# 12V/3A

Product Name: **B050**
Product Description: **A176 - Cyclone**
Document Number: ESMB050-00
Page Size: C
File Name: ESMB050.DSN
Configuration: <Variant Name>
Revision: 2.0
Sheet 11 Of

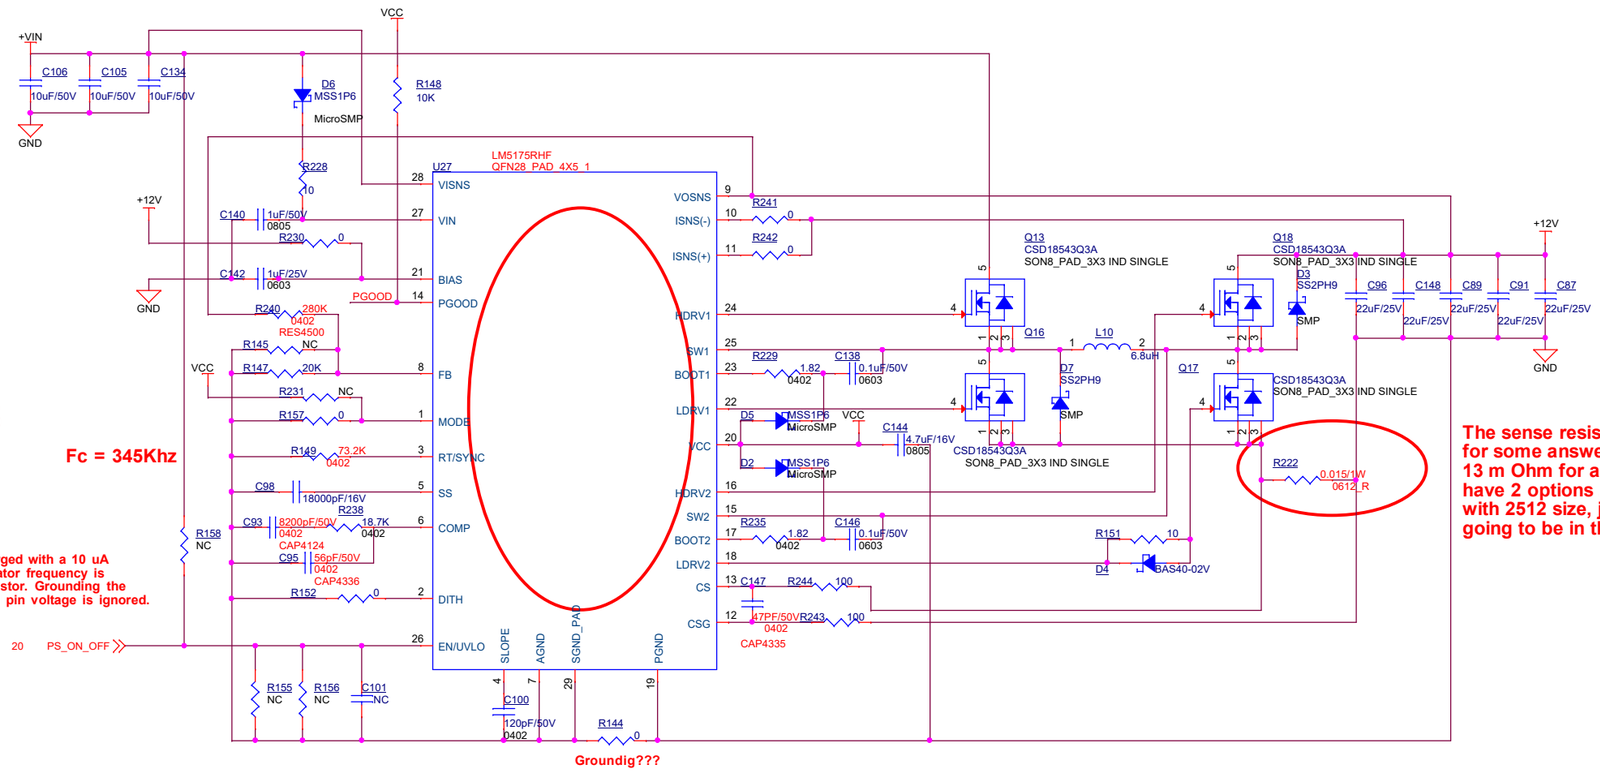
**The sense resistor is not final waiting for some answers but it as to be 11 to 13 m Ohm for a 3A output power. we have 2 options ,one with 1206 and one with 2512 size, just one of them is going to be in the circuit/**

## All parts marked witg green circle has to replaced by the correct Aitech PN from Data base

## New Parts Requiered

**Resistor 73.2K 0402**

**Controller LM5175RHF from TI VQFN-28**
